Vale of Glamorgan Highway Authority Observation Sheet

Planning Application Ref:	2019/00871/OUT
Observations By:	Nigel Rees
Date:	1 st December 2022
Location:	Land at Model Farm, Port Road, Rhoose
Proposal:	Outline application comprising demolition of existing buildings and erection of 44.79ha Class B1/B2/B8 Business Park, car parking, landscaping, drainage infrastructure, biodiversity provision and ancillary works. All matters reserved aside from access.
Case Officer:	Mr. Ceiri Rowlands

Planning Application Ref:	2019/00871/OUT
Observations By:	Nigel Rees
Date:	20 th May 2021
Location:	Land at Model Farm, Port Road, Rhoose
Proposal:	Outline application comprising demolition of existing buildings and erection of 44.79ha Class B1/B2/B8 Business Park, car parking, landscaping, drainage infrastructure, biodiversity provision and ancillary works. All matters reserved aside from access.
Case Officer:	Mr. Ceiri Rowlands

Site plan Ref A

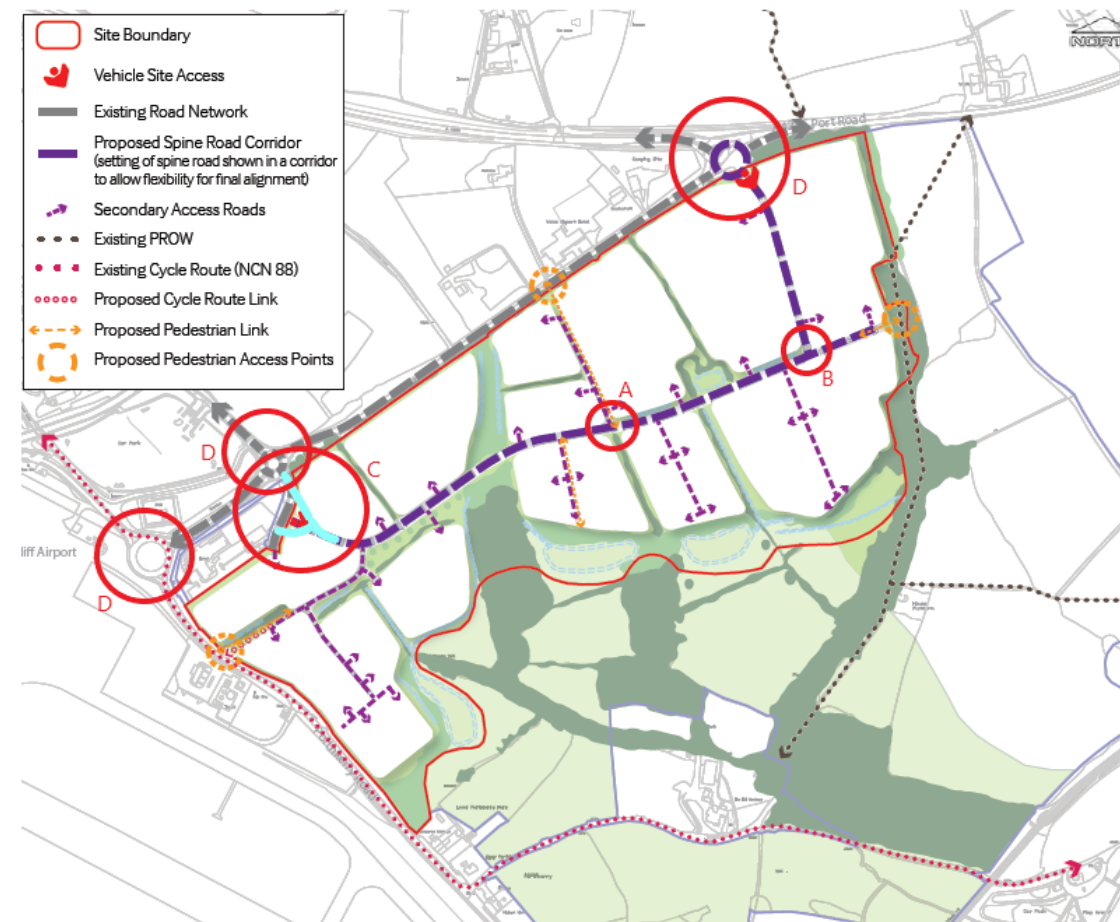
- All internal roads to be designed and constructed to an adoptable industrial & commercial estate standards for geometry and road construction makeup.
Internal road widths to be 7.3m wide, carriageway widening at bends to 8m
Junction kerb radii to be 15m.
Carriageway gradients to be 1:12max.
Junction spacing 80 same side and 40m opposite.
Main internal access roads to be designed for 30mph design speeds, forward visibilities and alignment radii to be designed to suit. visibility splays at junctions: 'Y' dist to suit 30mph design speed with an 'X' dist of min 45. max 9.0m.
Suitable turning heads at cul-de-sac, to be tracked for articulated vehicles.
All roads to be cambered with a fall of 1:36.

- Provide suitable active travel routes connections and routes through the development with 3.5m wide shared footway surfaces and suitable pedestrian/cycle crossings.

- Provide public transport facilities with bus laybys, stops and shelters.
 - Proposed pedestrian links and access points to be for shared use pedestrian and cycle to tie in with proposed shared surfaces throughout the development.

- A. Due to the nature of the development land parcel the access road has long straights which will promote high speeds, provide a roundabout at this location which will serve as a speed reducing feature and access to the side land parcels

- B. The highway alignment at this point shows a 90 degree bend which is not ideal, provide a roundabout at this location.

- C. The access shown at his location gives priority to the existing hotel, priority to be changed to give priority to the proposed development with a side access to the hotel with a possible ghost right hand turning lane depending on vehicle modelling flows.

- D. Existing roundabouts to be modelled and size and layout to be determined within the scope of the existing adopted highway and any land in the ownership of the applicant. To take account of footways/shared surfaces and verges and embankments supporting the highway.
- The drawings show the provision of a 3m plus wide verge running along Port Road adjacent to the development. The highway Authority would look for the developer to provide a 3.5m wide shared footway from the roundabout on A4226 along Port Road to the roundabout on Porthkerry Road and along Porthkerry Road within the frontage of the proposed development, to provide active travel routes from the surrounding areas into the development. Existing footway/cycle facilities on A4226 to tie into proposed along Port Road.
